MEMPHIS AND SHELBY COUNTY OFFICE OF PLANNING AND DEVELOPMENT
STAFF REPORT **# 15**

CASE NUMBER: P.D. 08-334 **L.U.C.B. MEETING:** January 8, 2009

DEVELOPMENT NAME: Germantown Storage Planned Development

REQUEST: The request is for a self-storage facility with outdoor vehicle storage

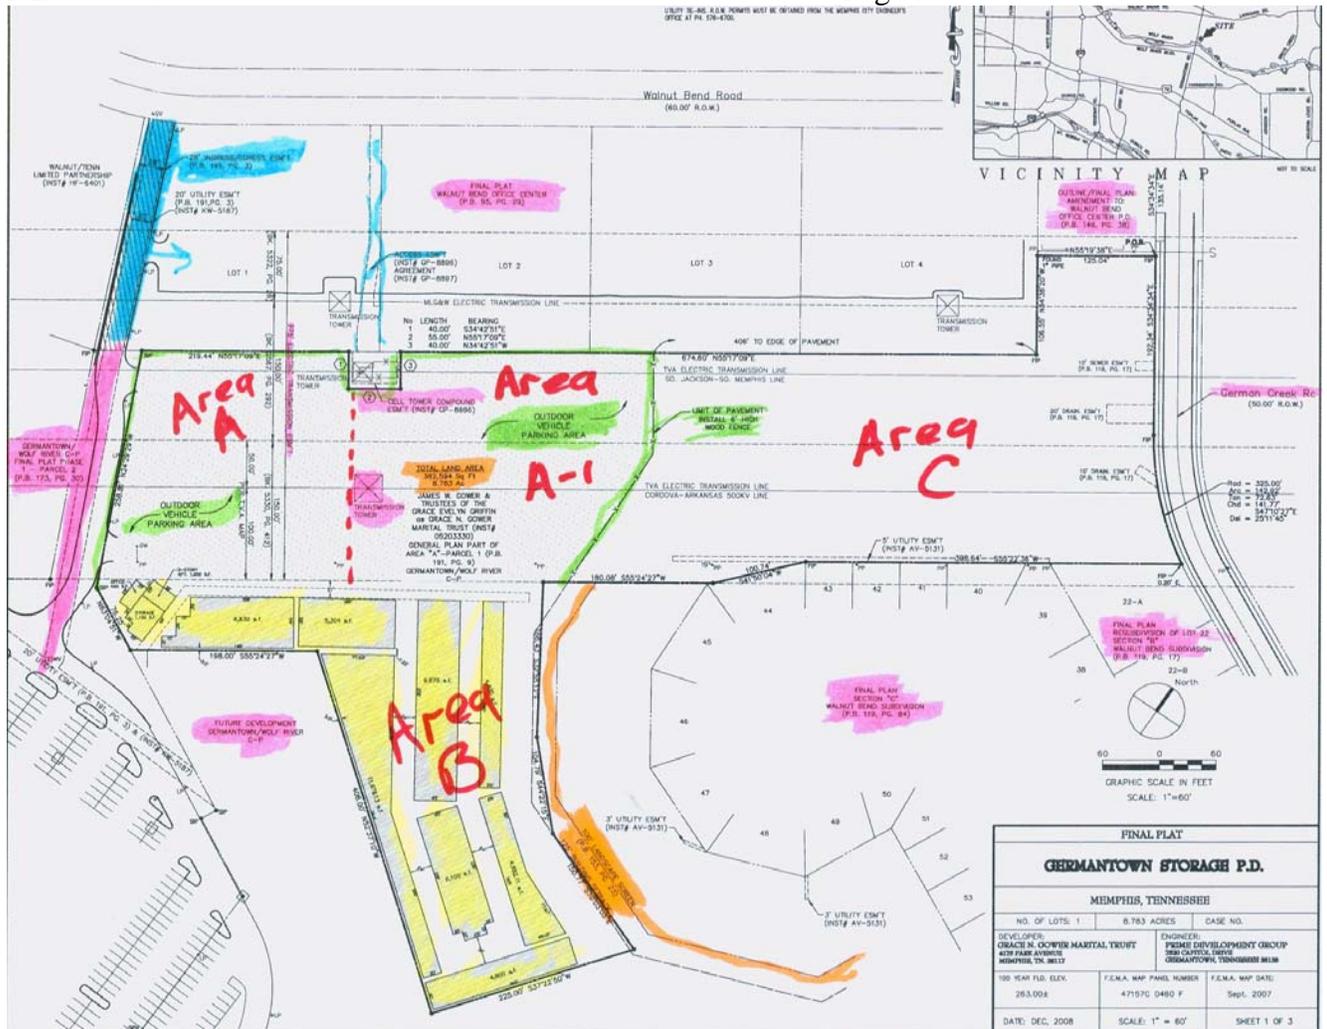
2. The proposal is recommended for approval subject to the following requirements to provide adequate screening for the adjacent residential properties.

- a. **Area "A"** shall allow for the storage of larger recreational vehicles and commercial buses and trucks. **Area "A-1"** shall allow for the storage of smaller vehicles only, any vehicle that exceeds seven (7') feet if prohibited.

- b. Increase the fence height from six (6') feet to eight (8') feet and extended southwardly along the eastern and southern boundaries of **Area "B"** in an effort to reduce any visual impact from the adjacent residential area. Install a equivalent alternative to Landscape Plate "N-1" along the southern boundary of the landscape buffer area, in an effort to screen any future commercial uses from the adjacent single family residential area.

- c. ***Any future use of Area "C" shall require site plan approval by the Land Use Control Board.*** It is recommended that service and maintenance of the grass and trash for **Area "C"** be performed on this site at least two (2) times in between the months of May and September. This request will not be will not be unduly detrimental to other properties and will be in reasonable harmony with the character of the area where the property is located.
